SUBJECT: PLANS AND PROPOSAL ADDENDUMS
PROJECT: STP 2023 (675)MM CONTROL: 1433-02-044
COUNTY: COMAL
LETTING: 05/04/2023
REFERENCE NO: 0419

PROPOSAL ADDENDUMS

DESCRIPTION OF ABOVE CHANGES
(INCLUDING PLANS SHEET CHANGES)

BRACKEN DR/GOLL ST
 @ STA. 37+75.92
 SEE BRACKEN DR/GOLL ST
 PLAN SHEETS FOR ADDITIONAL DETAILS
 AND QUANTITIES

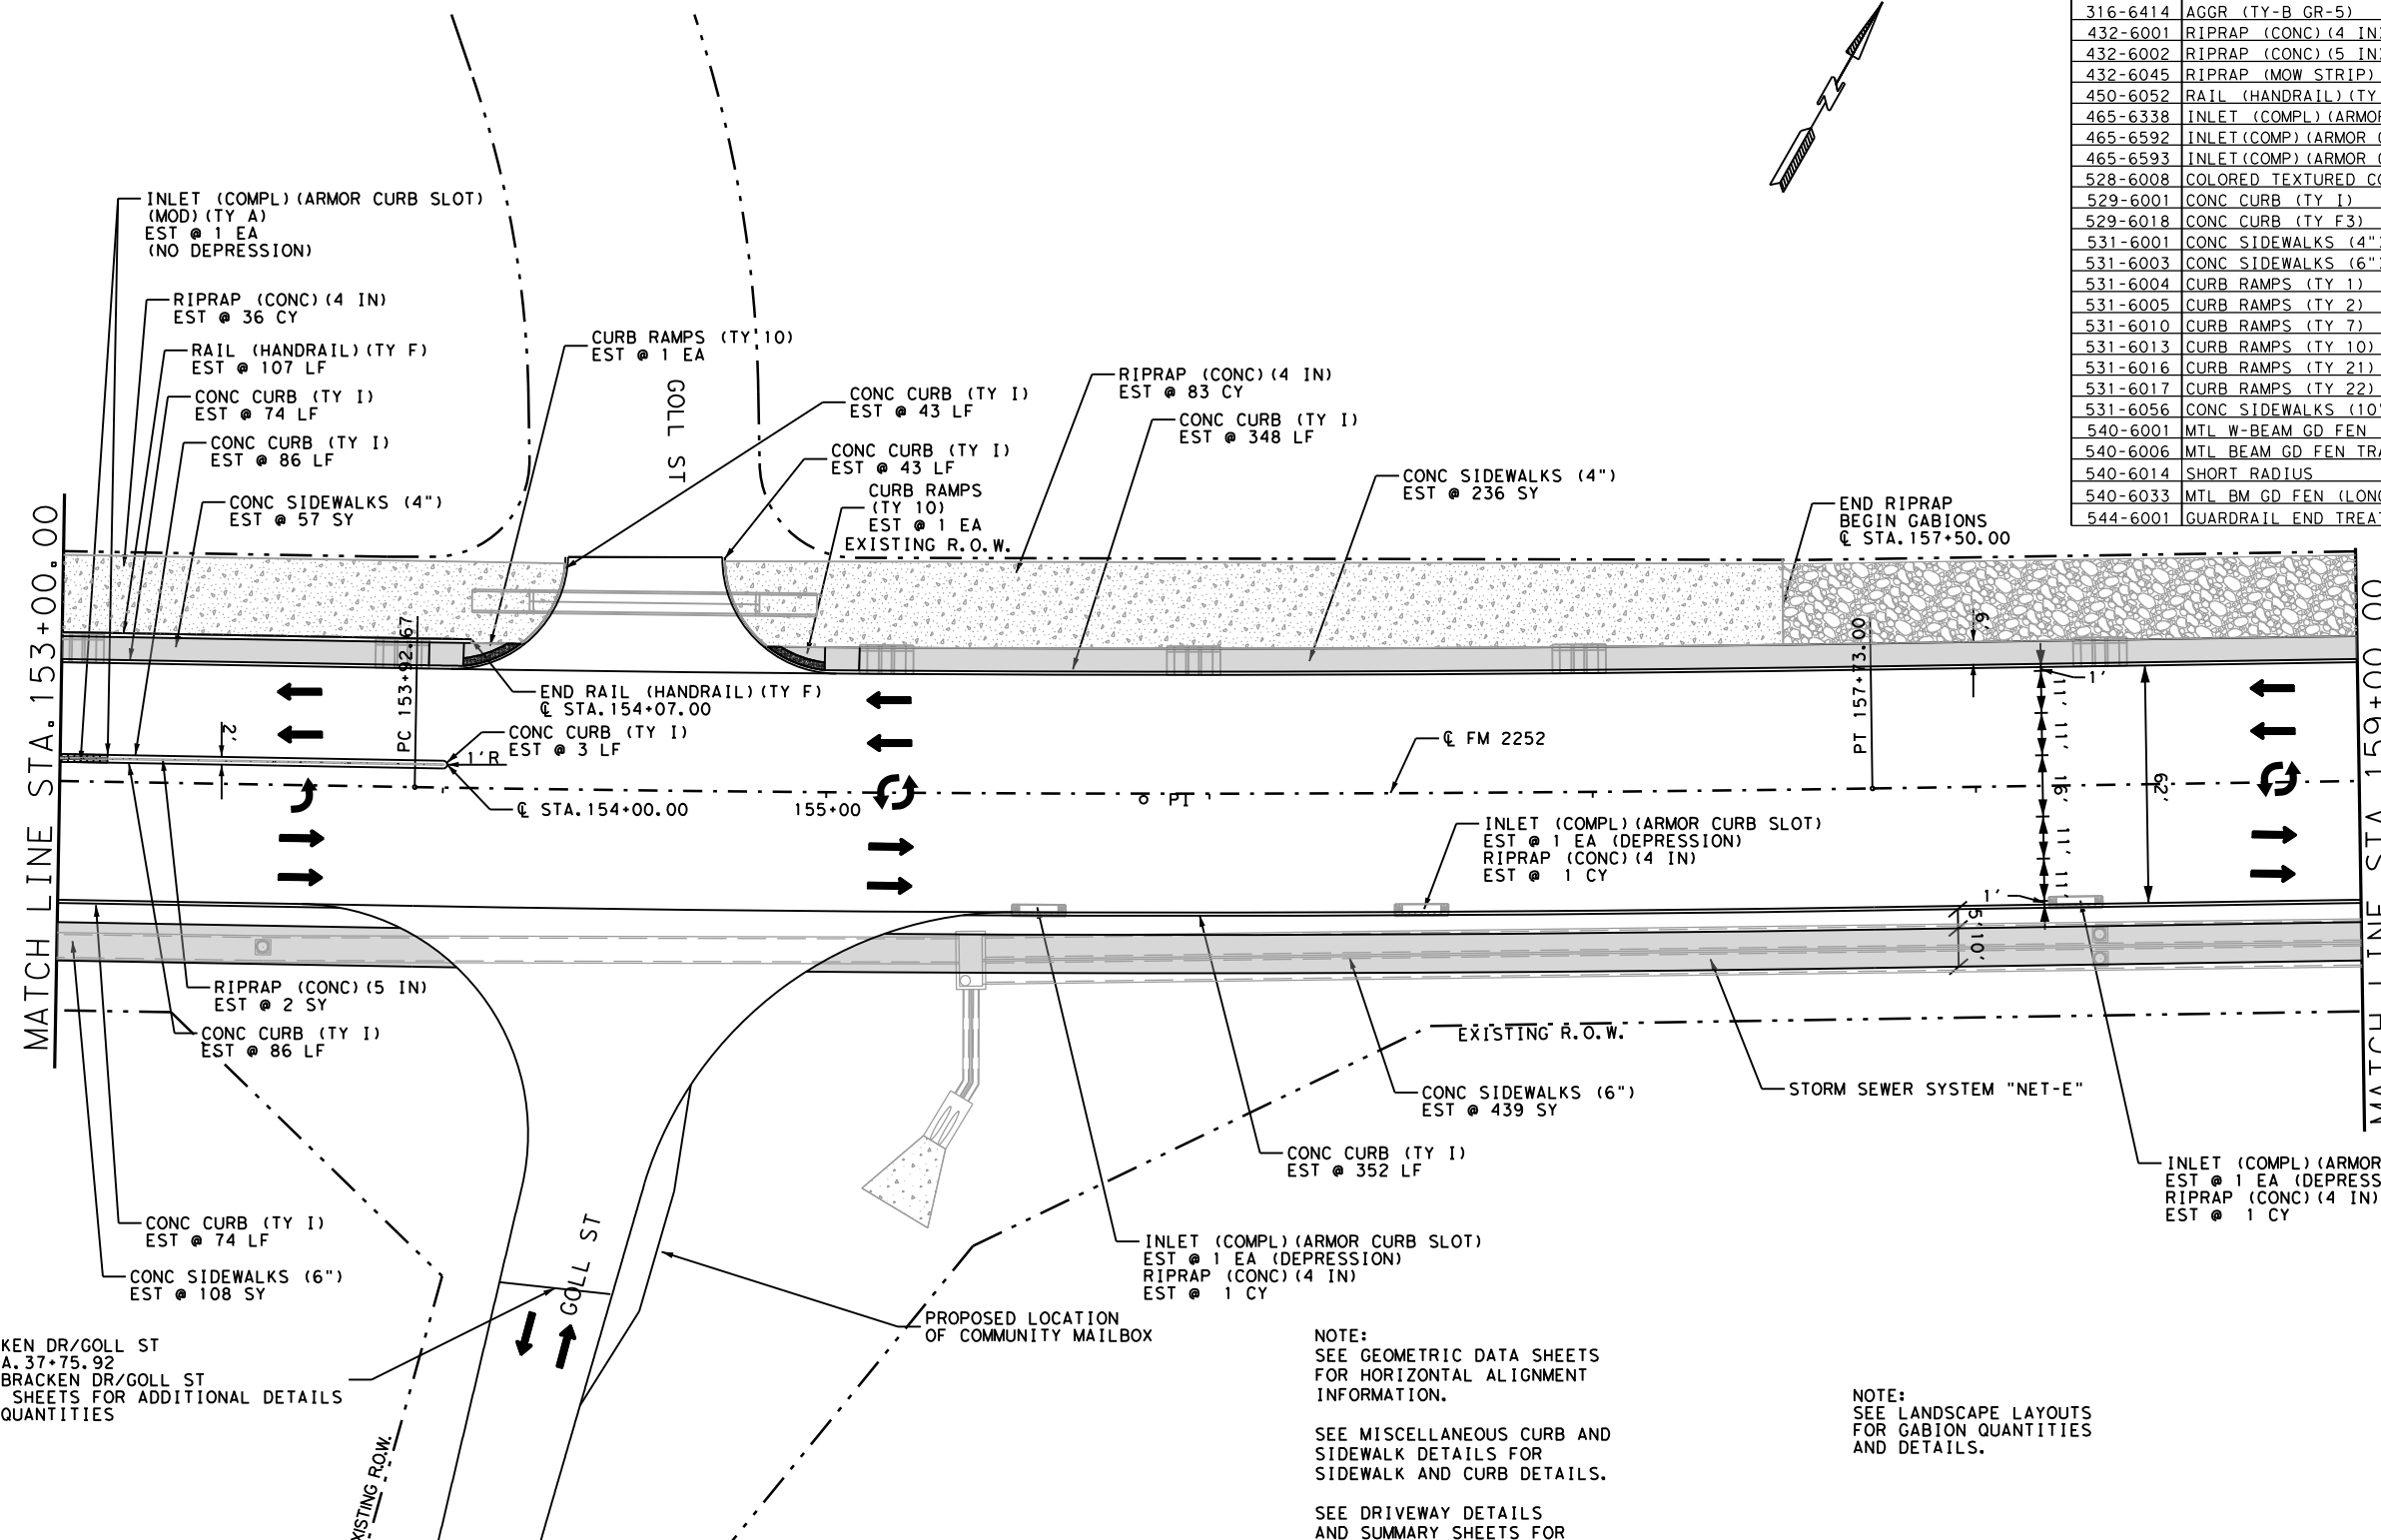
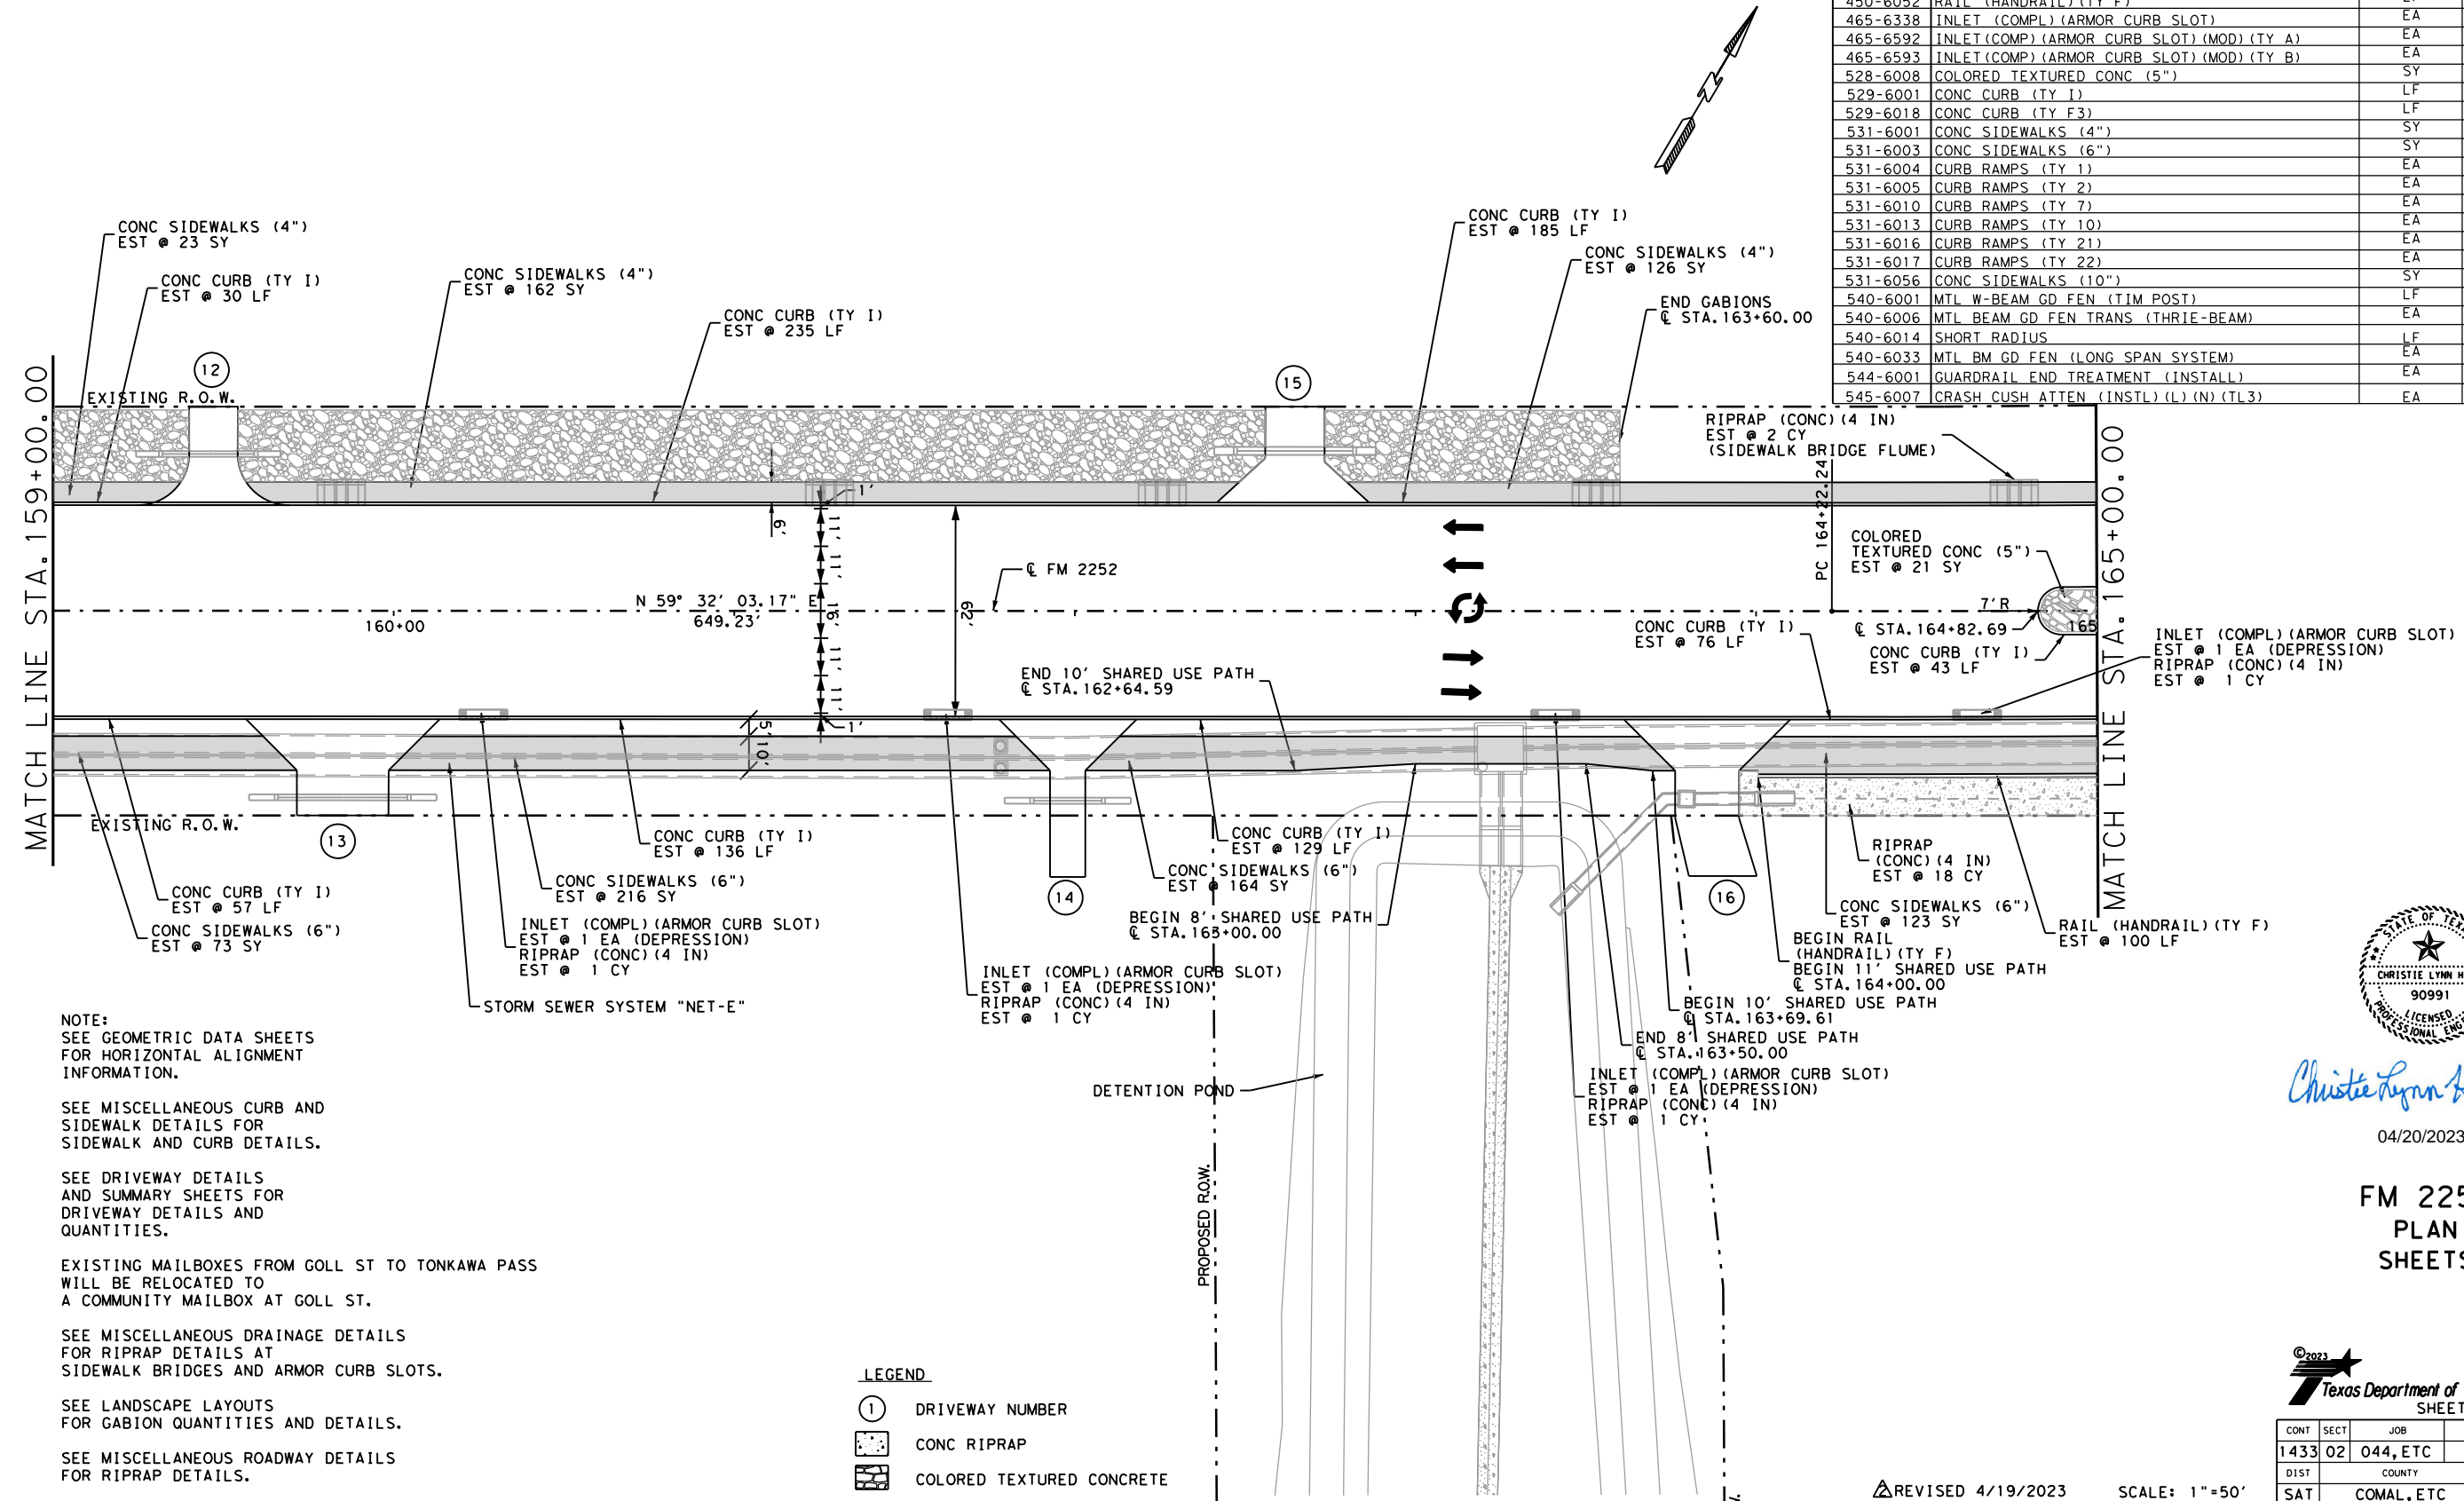
SHEETS 413-449: REPLACED ITEM NO. 545-6017 WITH ITEM NO. 545-6007
